Commercial/Multi-Family Design Review Committee

1. [26-0016](#) Review of plans for the commercial addition located at 610 Hagar/632 Rose Streets.

MEMORANDUM

SUBJECT: COMMERCIAL DESIGN REVIEW PROJECT
632 ROSE/610 HAGAR STREETS

PROPOSED EXTERIOR ELEVATIONS

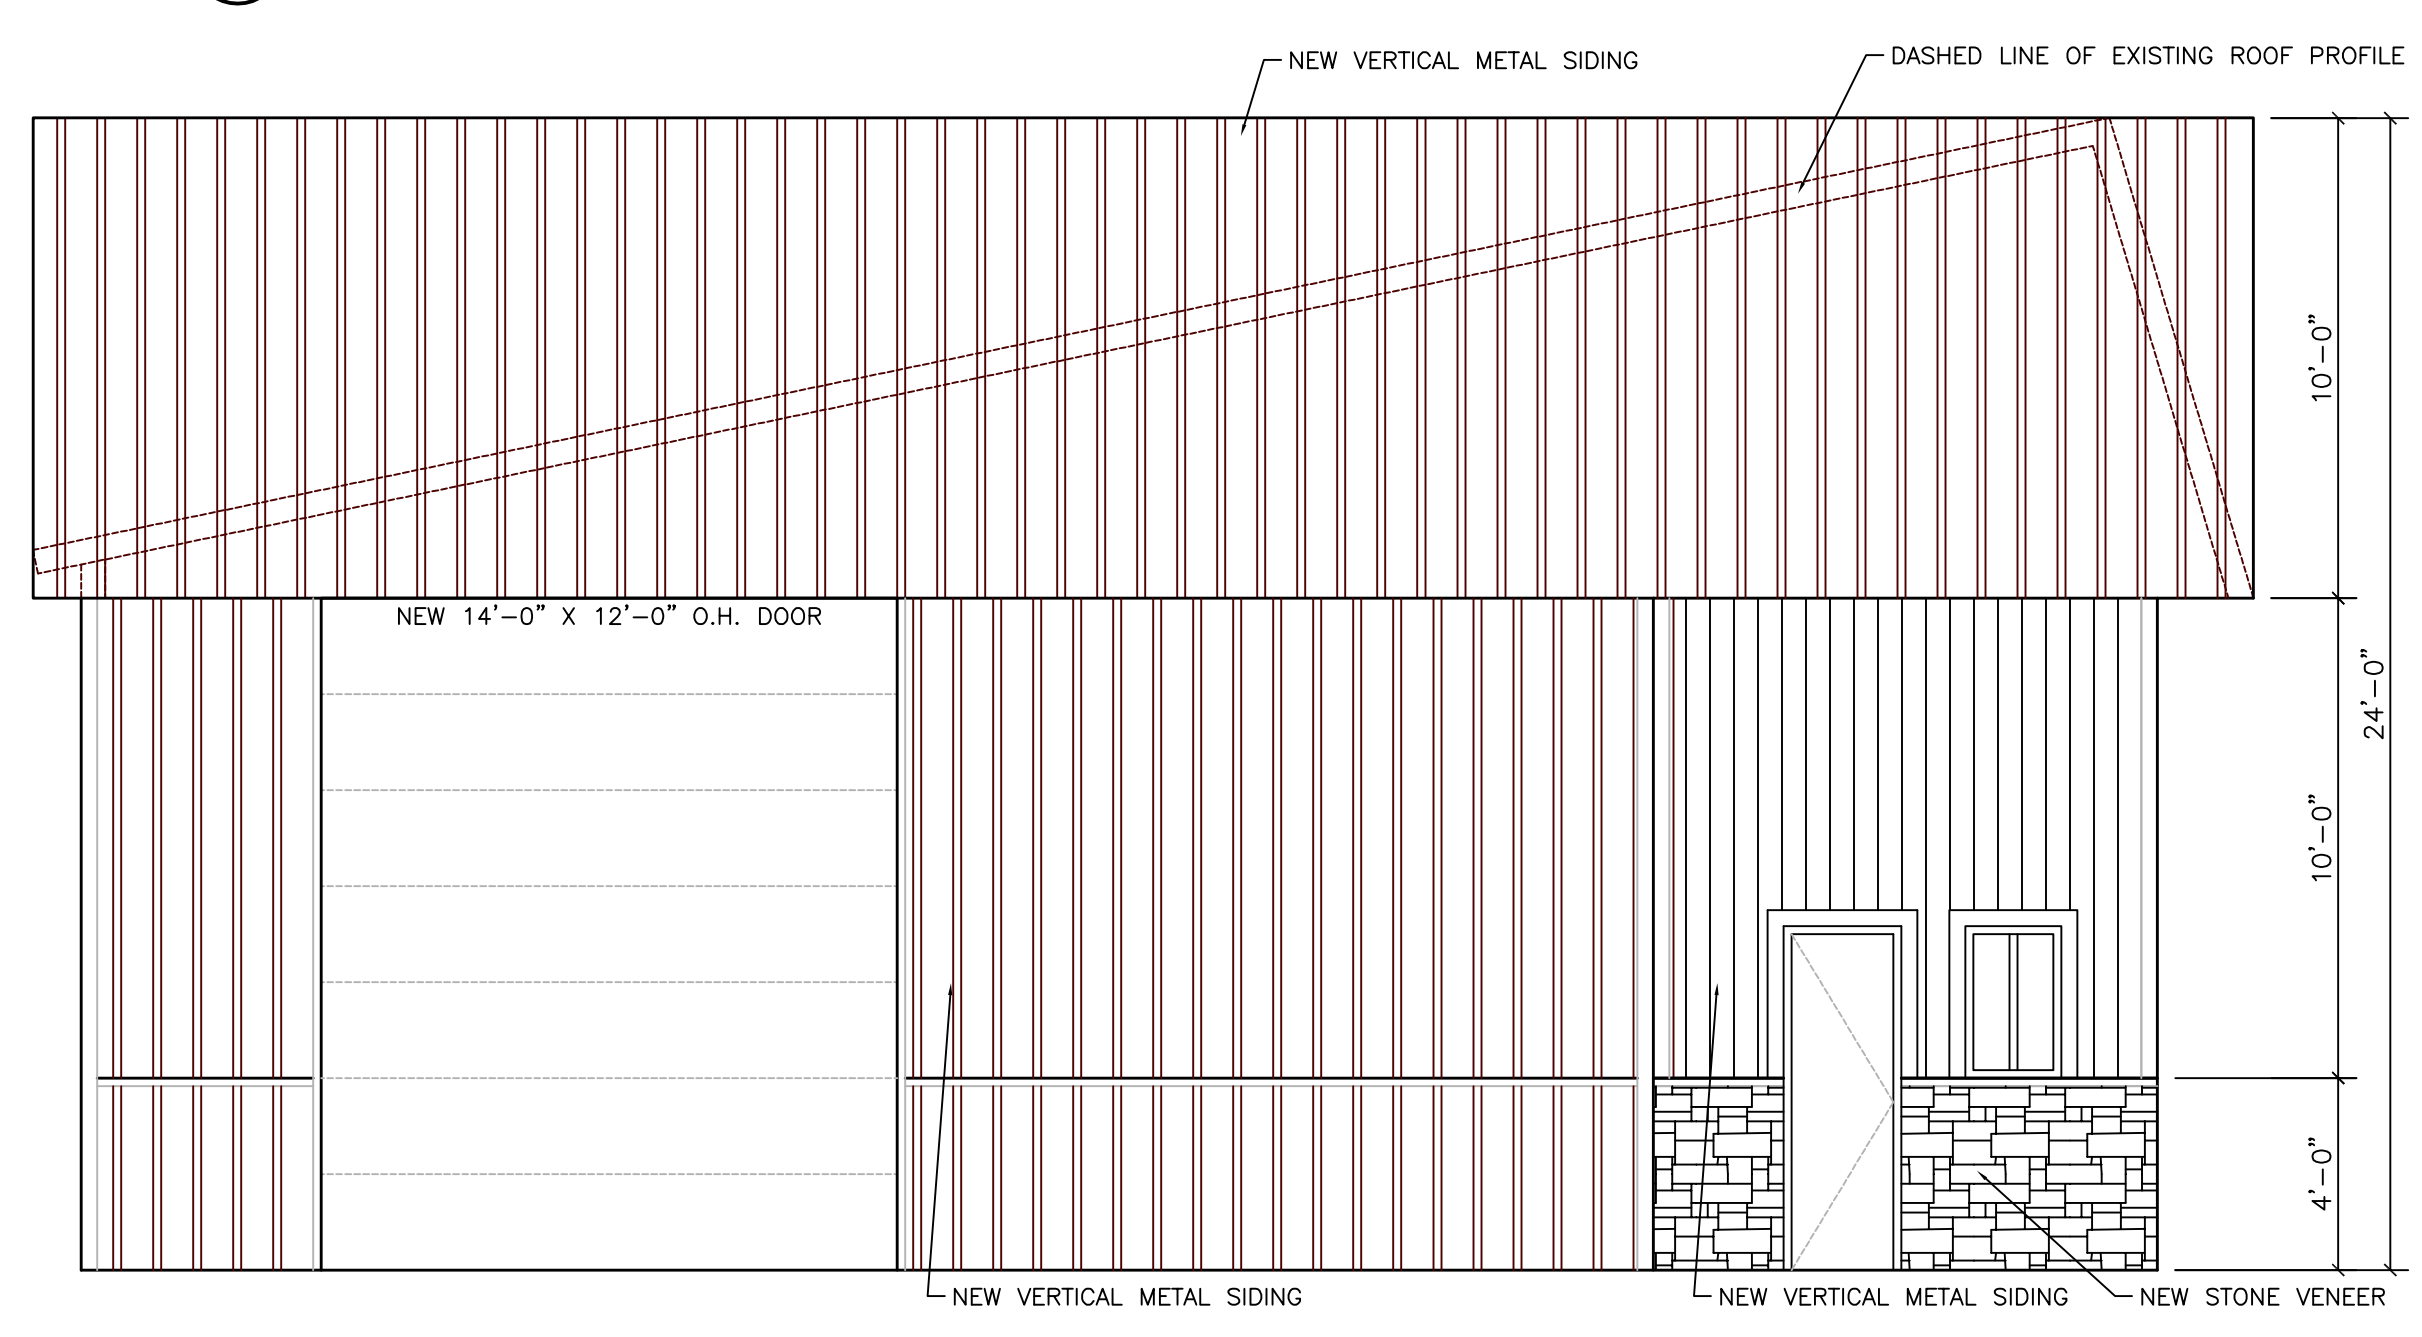
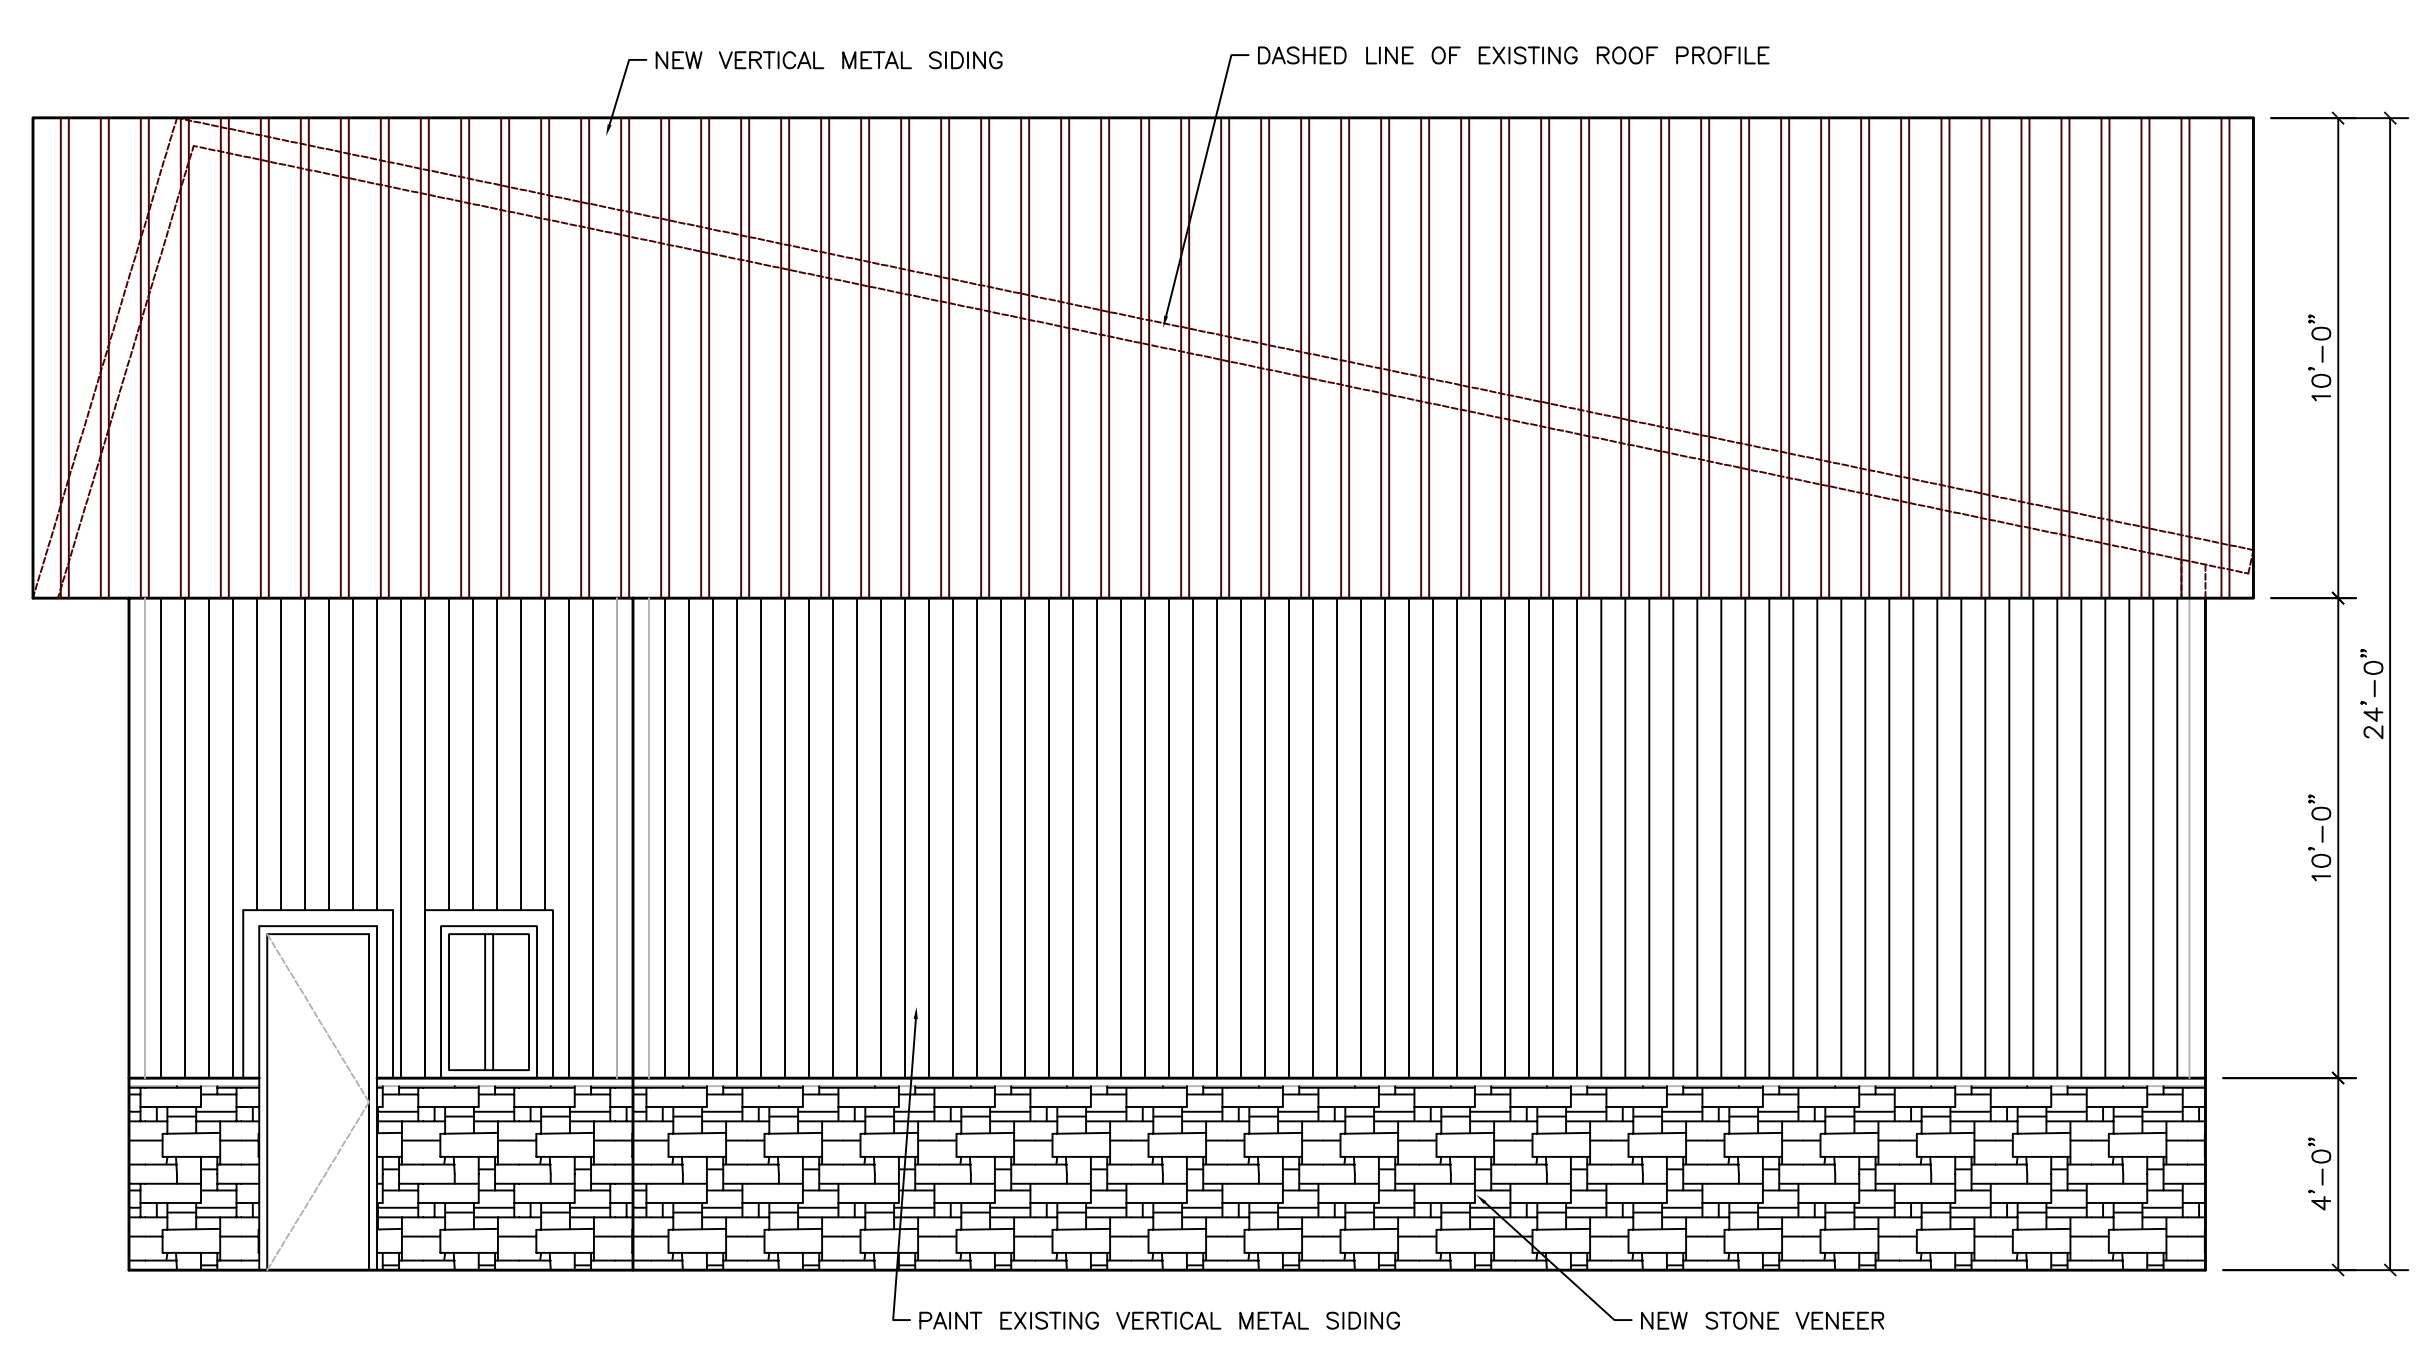
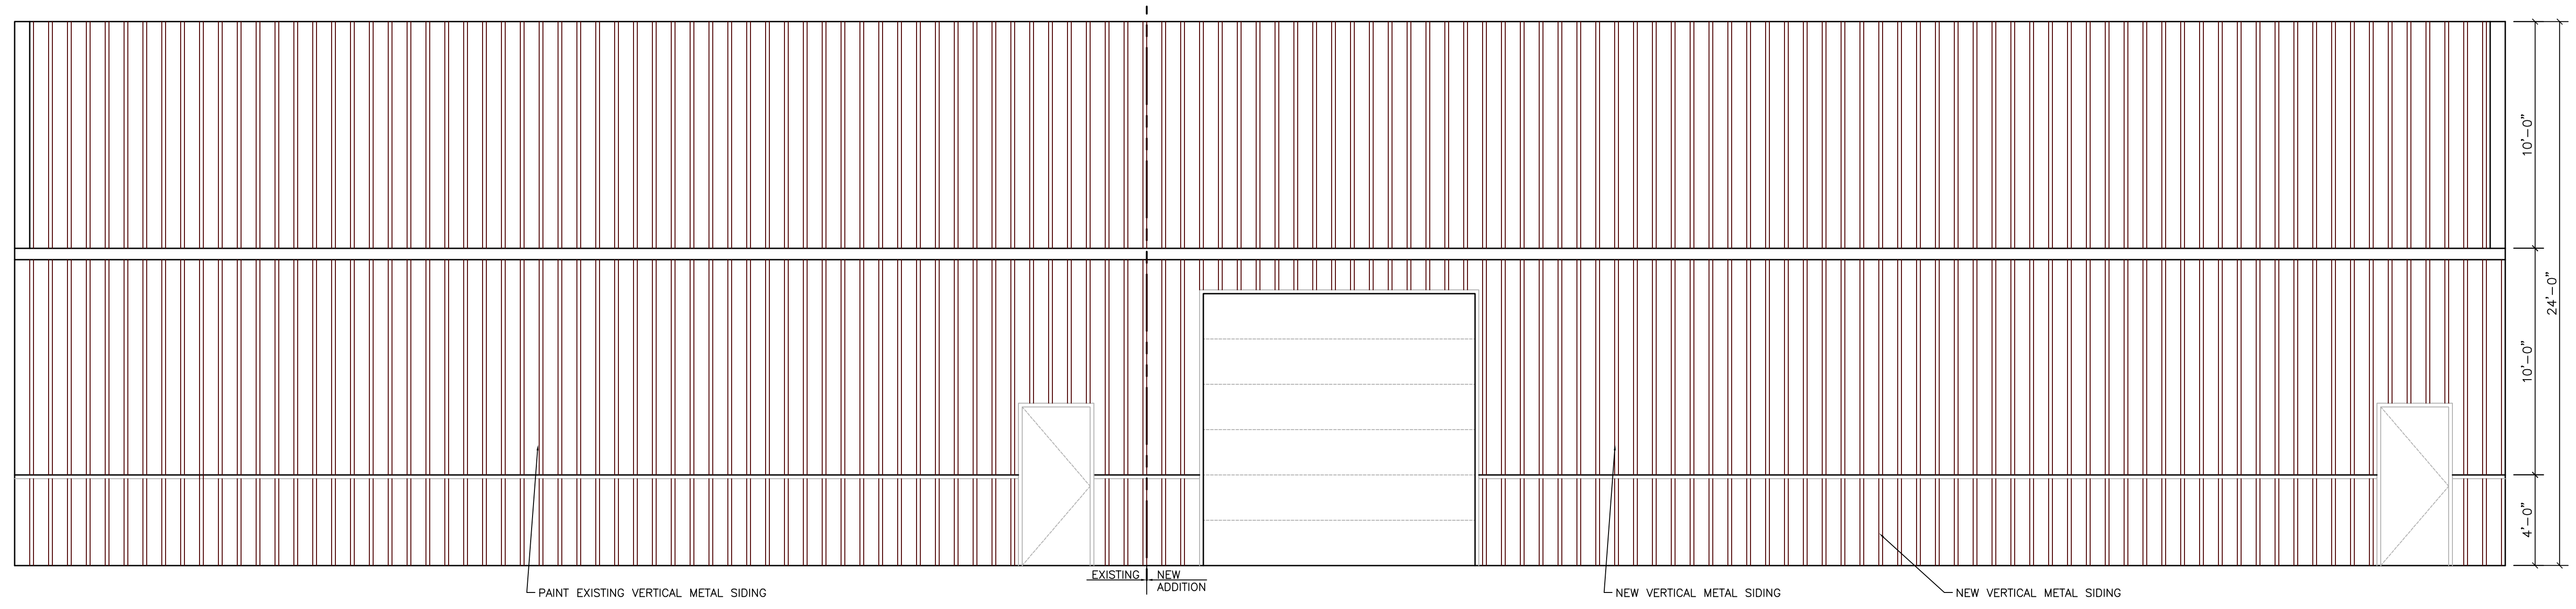
- 1) Would like stone veneer around building the whole building.
- 2) Non-Architectural metal is being proposed as a primary siding material. Work with staff on a different, permitted exterior material.
- 3) Link to Design Standards
 - a. <https://www.cityoflacrosse.org/home/showpublisheddocument/6084/637847479856030000>
- 4) Any exceptions to the design standards will need Common Council approval.
 - a. <https://www.cityoflacrosse.org/your-government/departments/city-clerk/forms-chart/request-for-exception-to-multi-family-housing-or-commercial-design-standards>
